Interactive comment on “A cross-scale study for compound flooding processes during Hurricane Florence” by Fei Ye et al.

Interactive comment on Nat. Hazards Earth Syst. Sci. Discuss., <https://doi.org/10.5194/nhess-2020-389>, 2020.

Fig. 13: Importance of resolving small-scale features on the order of a few meters in the watershed, illustrated by a comparison between a preliminary setup (a, b) and the

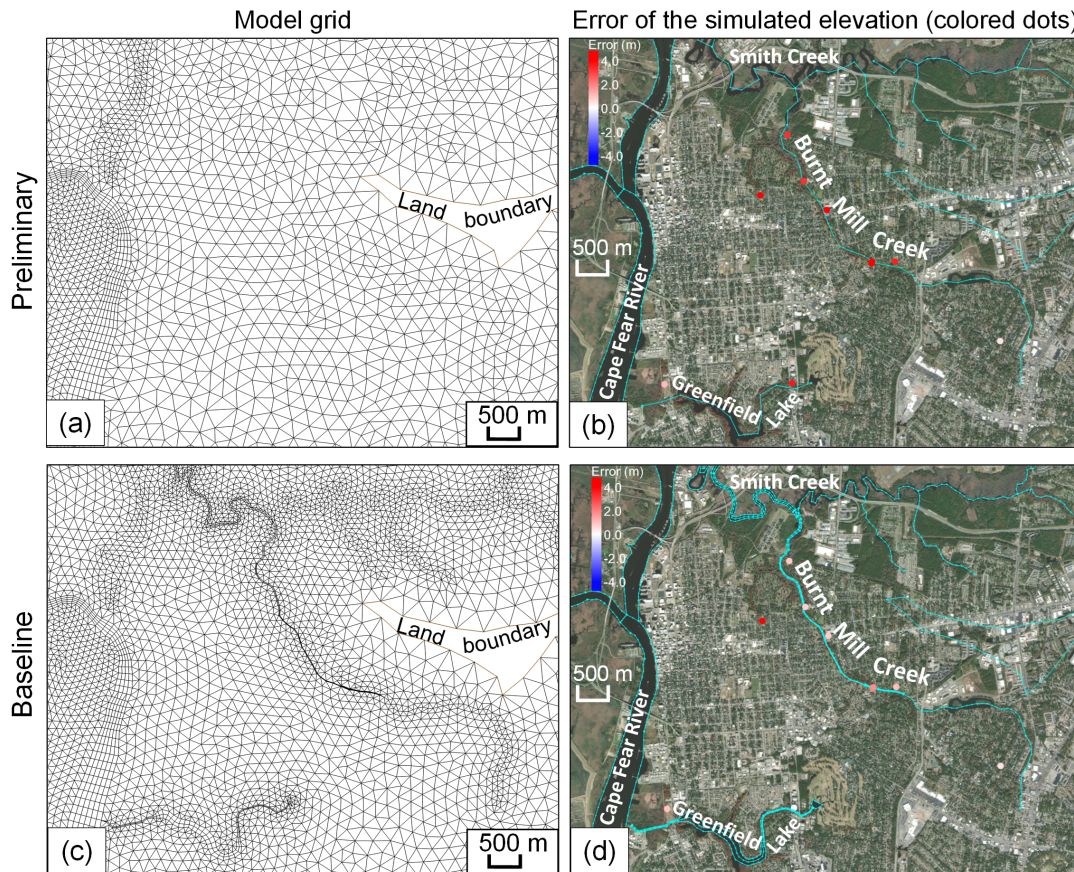
We found a minor problem with Fig. 13d and fixed it in the new Fig. 13 below. Specifically, a different run other than the baseline model was used to plot Fig. 13d in the original manuscript, which has been corrected. This does not change the conclusion that resolving small-scale flow routing features greatly improves the prediction of HWM elevation. The “Burnt Mill Creek” was mis-labeled as “Northeast Cape Fear River” in the original manuscript, which has been corrected. Lake Greenfield and more labels were also added for better illustration.

baseline setup (c, d). To better resolve the Burnt Mill Creek, NC, more SMS feature arcs (cyan lines in (d)) are used in the baseline setup than in the preliminary setup (cyan lines in (b)), significantly reducing the HWM errors. See Fig. 2 for the location of this locally zoomed-in region. The base maps in (b) and (d) are provided by ESRI.
